LB/9762

12th of September 2024**Former Mather & Platt Foundry, Grimshaw Lane, Manchester, M40 2BA****Planning Application Number: 135454/JO/2022****Discharge Condition Reference: CDN/24/0682**

Please find below responses and accompanying information in relation to latest comments on the submission to clear planning condition 13 on surface water drainage.

Planning Condition 13

DRAWING No
9762-PTA-XX-XX-DR-C- 8100

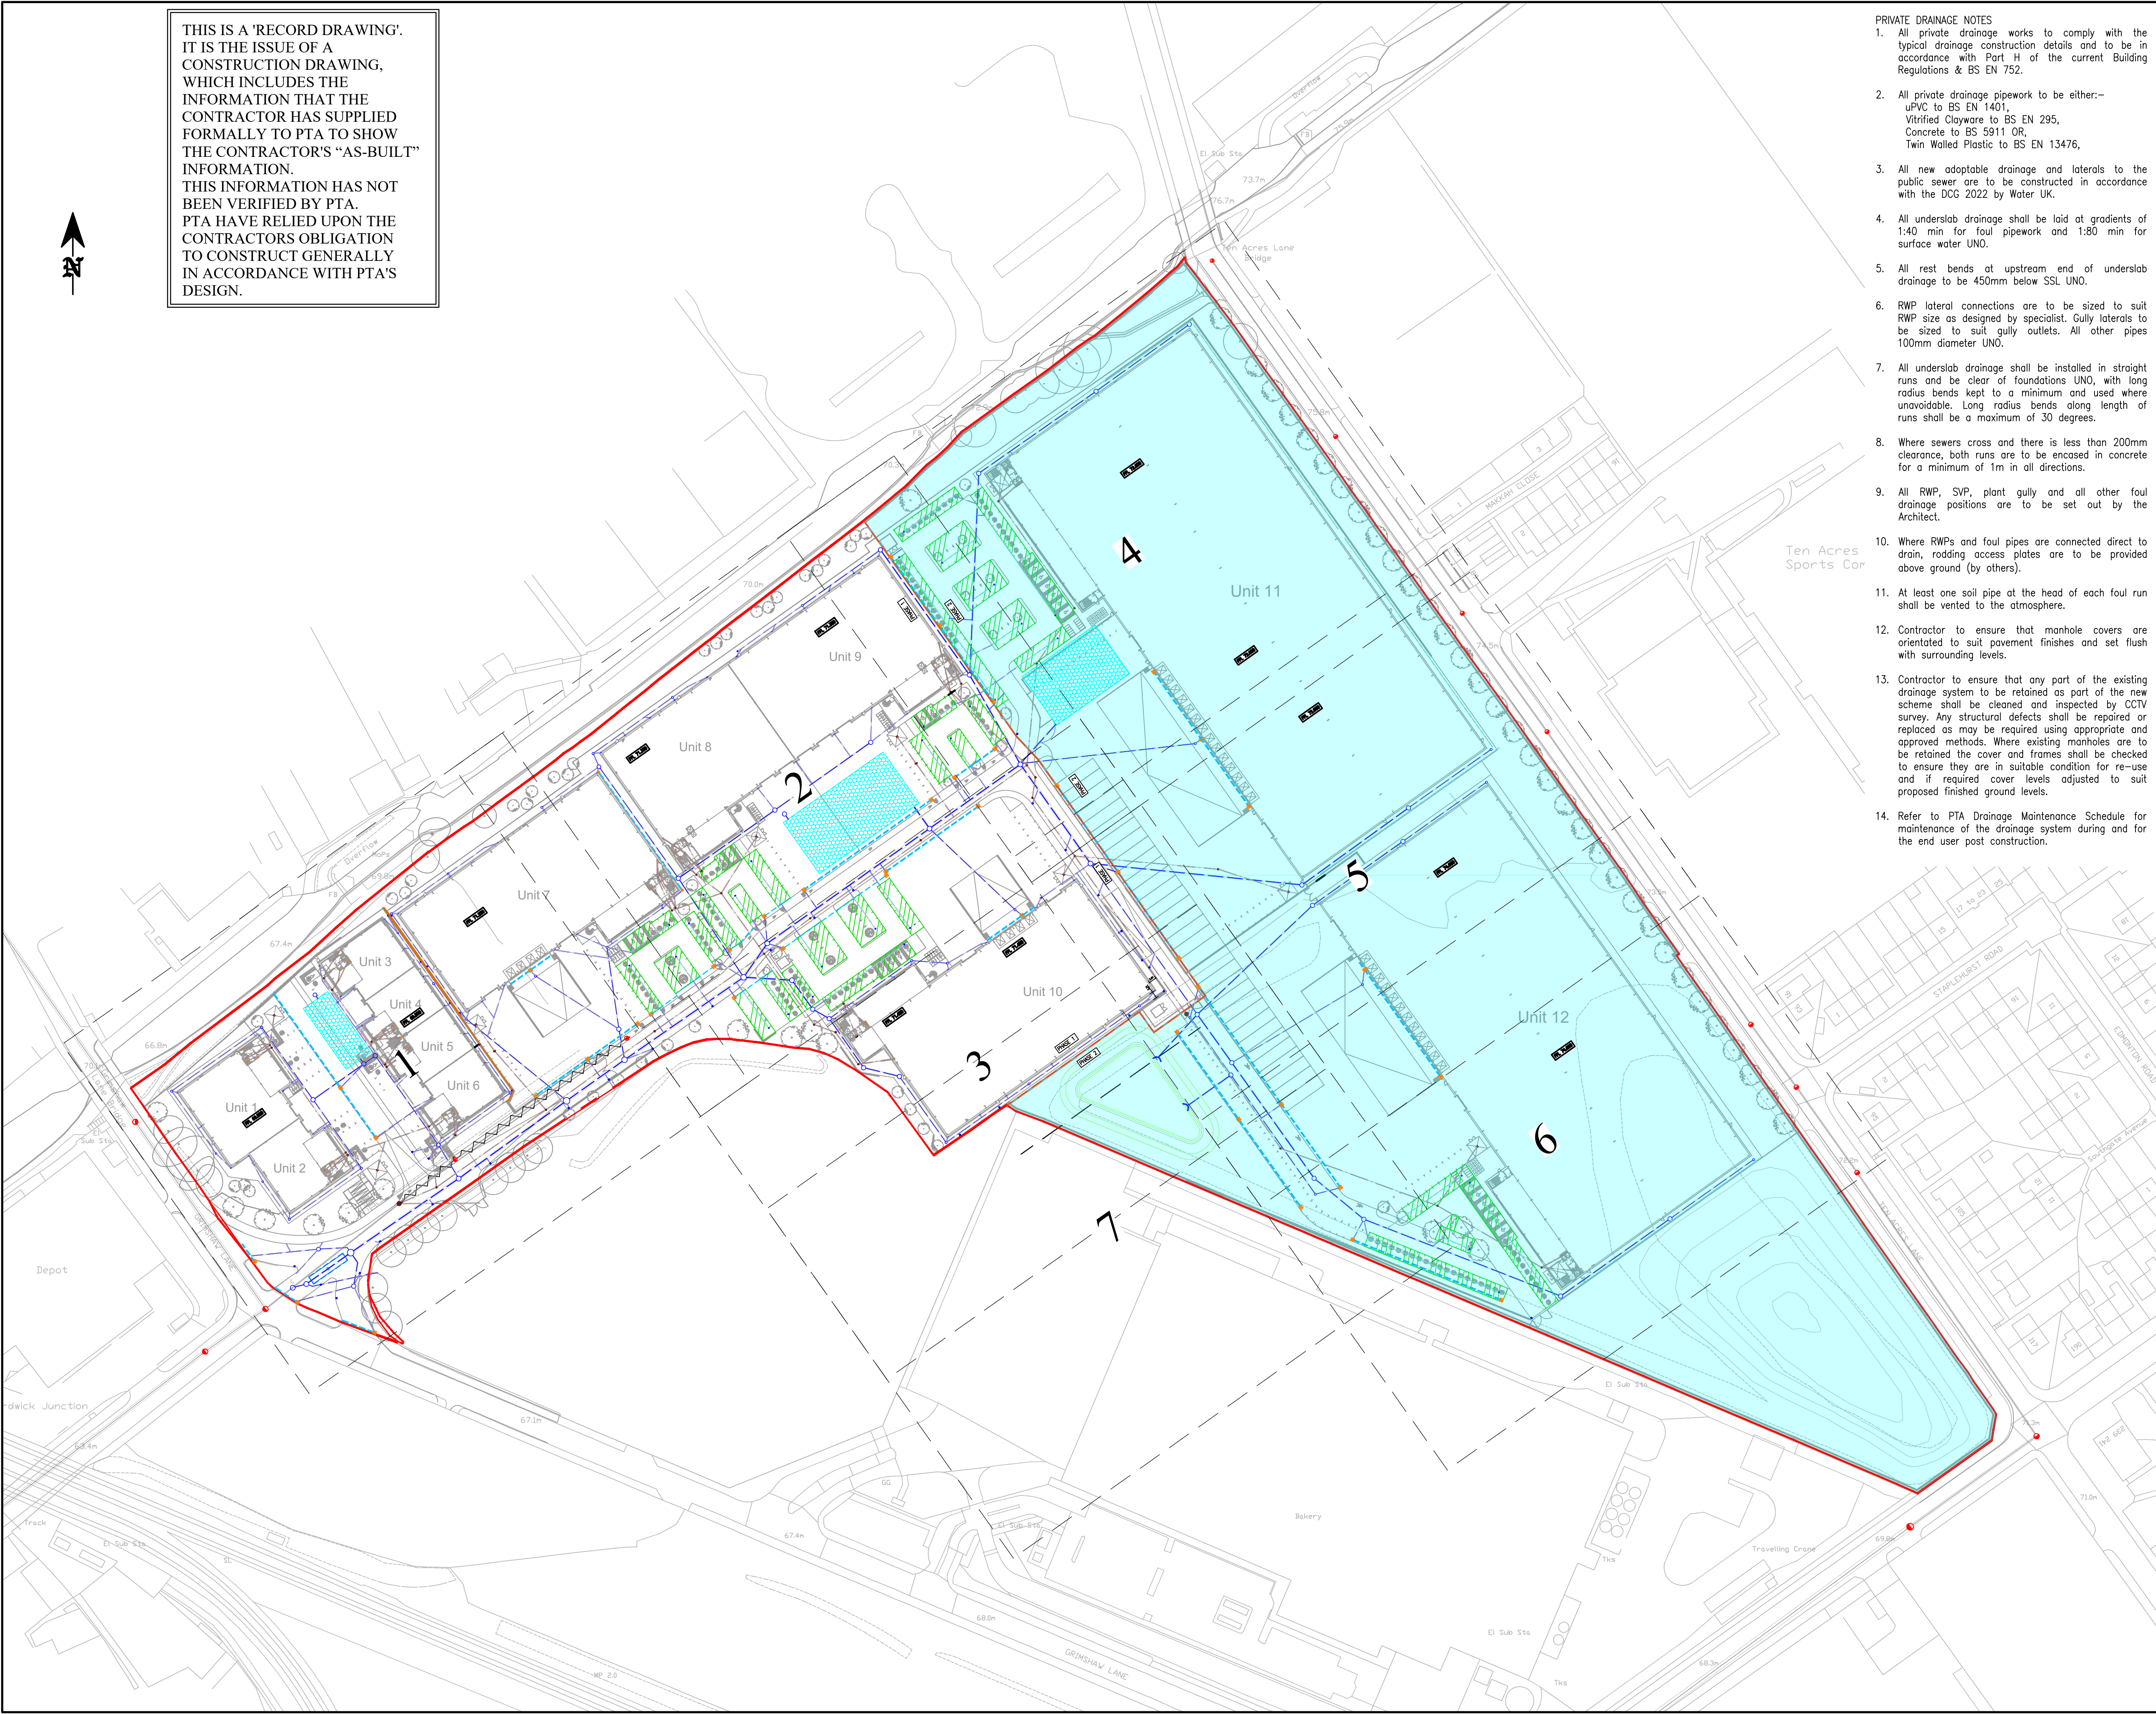
The developer needs to confirm drawing no. 9762-PTA-XX-XX-DR-C-8101, 2, 3 are the submitted as built details.

We can confirm that the below referenced drawings represent the as-built drainage networks for development phase 1.

9762-PTA-XX-XX-DR-C-8100 - Proposed Sitewide Drainage Layout - Rev C04

DATE	MARCH 2021	CHECKED DO	CHECKED ENG	PTA PROJ No
DRAWN	LB			9762
SCALE	1:250	LB	SLW	REVISION
DWG SIZE	A1			C07
DRAWING No	9762-PTA-XX-XX-DR-C- 8102

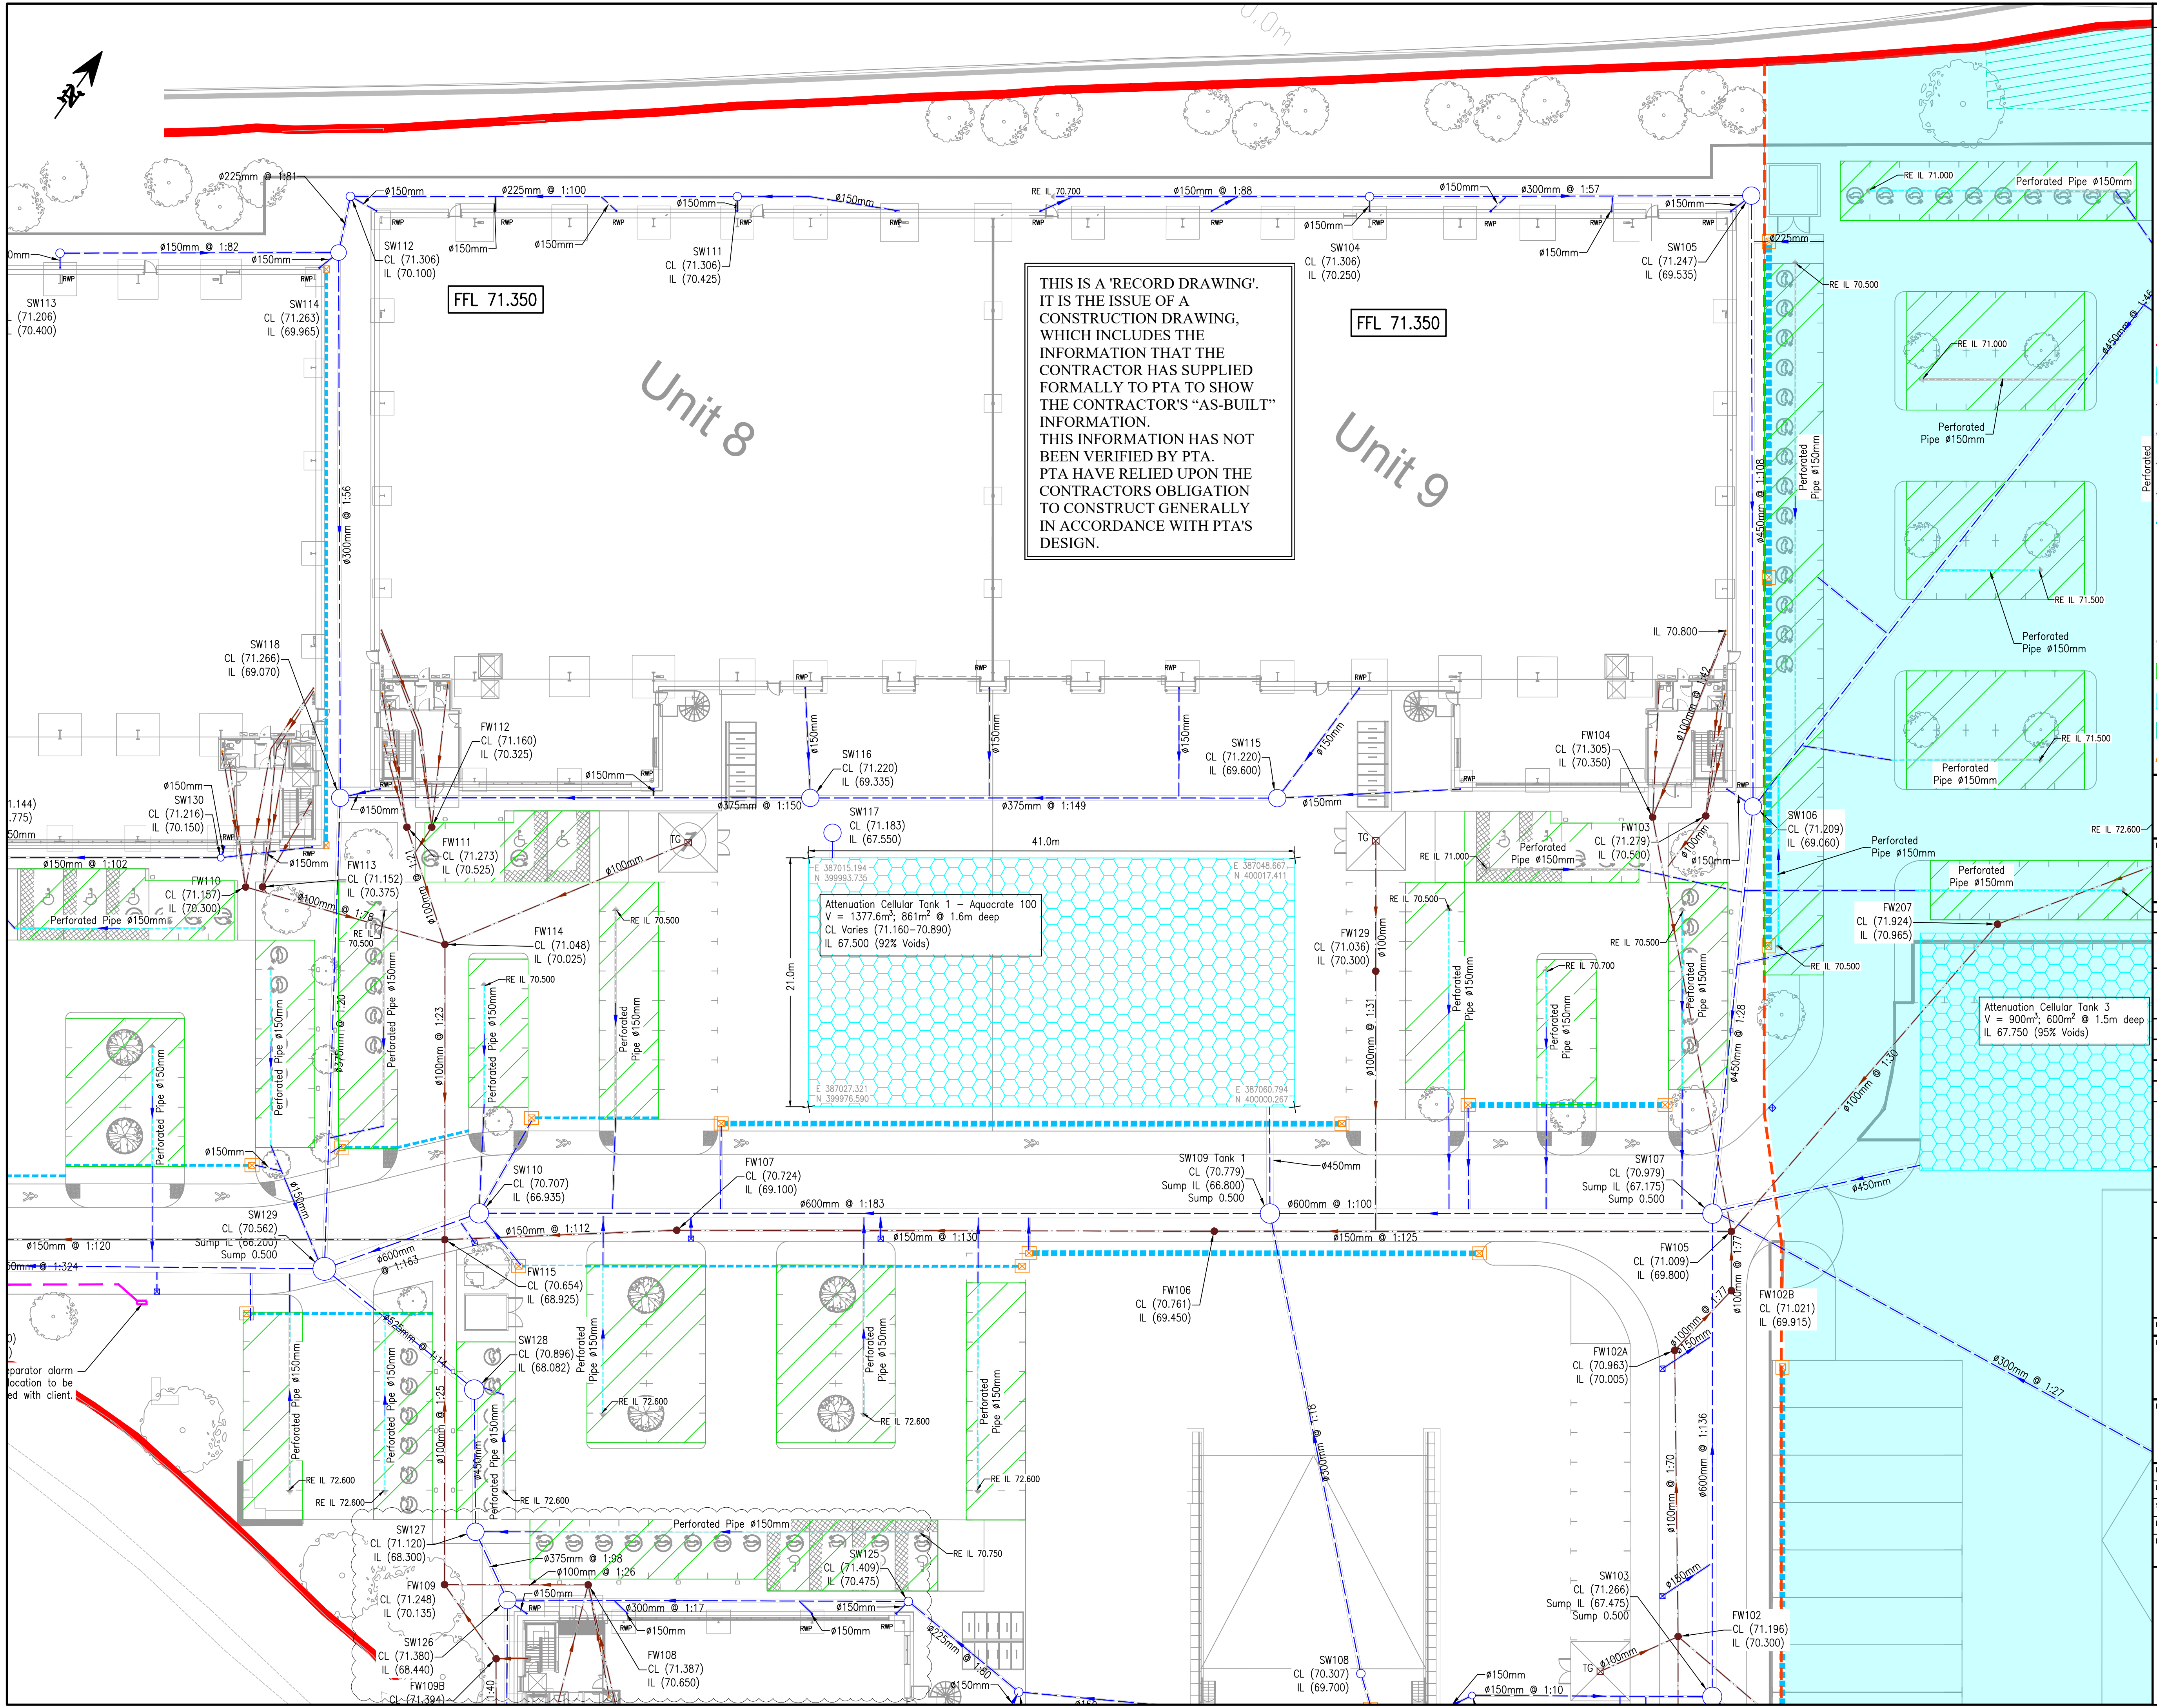
The developer must also provide the remaining four sheets, as the developer has currently only provided 1 – 3, out of a total 7 sheets.

9762-PTA-XX-XX-DR-C-8102 - Proposed Drainage Sheet 2 of 7 - Rev C07

Sheets 4 to 7 of the proposed drainage layout show Phase 2 area which is not currently being considered for the discharge of this condition, and as such have not been included.
